ION Audio LLC
200 Scenic View Drive, Cumberland, RI 02864, U.S.A.
TEL: 886-2-2717-2389 FAX: 886-2-2717-2389

Class II Permissive Change Letter

FCC ID: **2AB3E-IPA91**

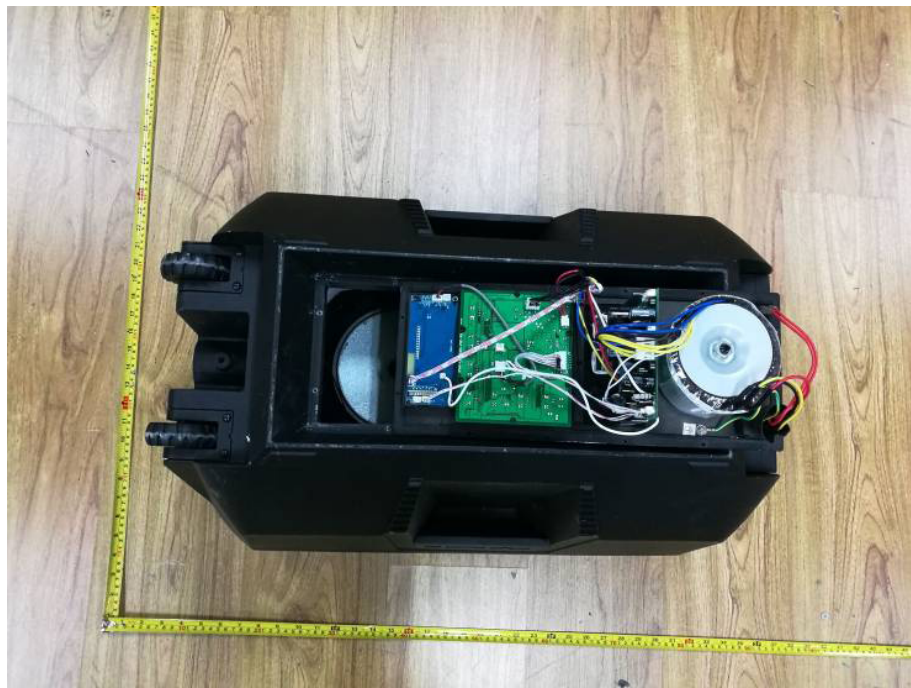
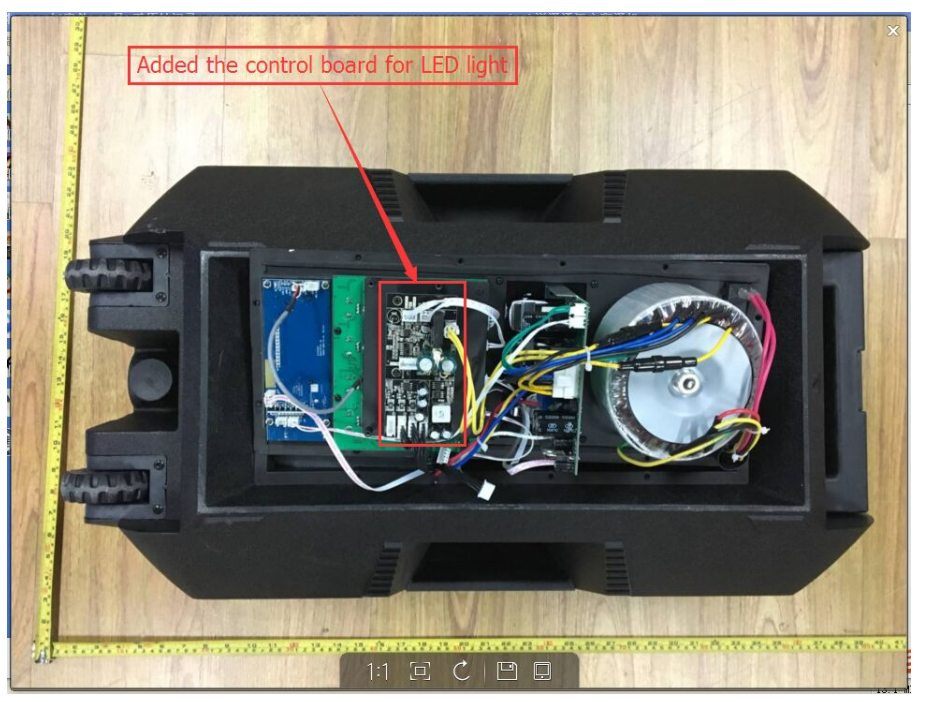
The only difference between the old and the new model is, the new model adds a light ring, thus add the control board for LED light. Power and all other specifications have not changed.

As RF circuit and Antenna keep the same with original approved one, there is **only change of non-transmitter portions**, Field Strength of Spurious Radiation testing was performed to demonstrate RF compliance
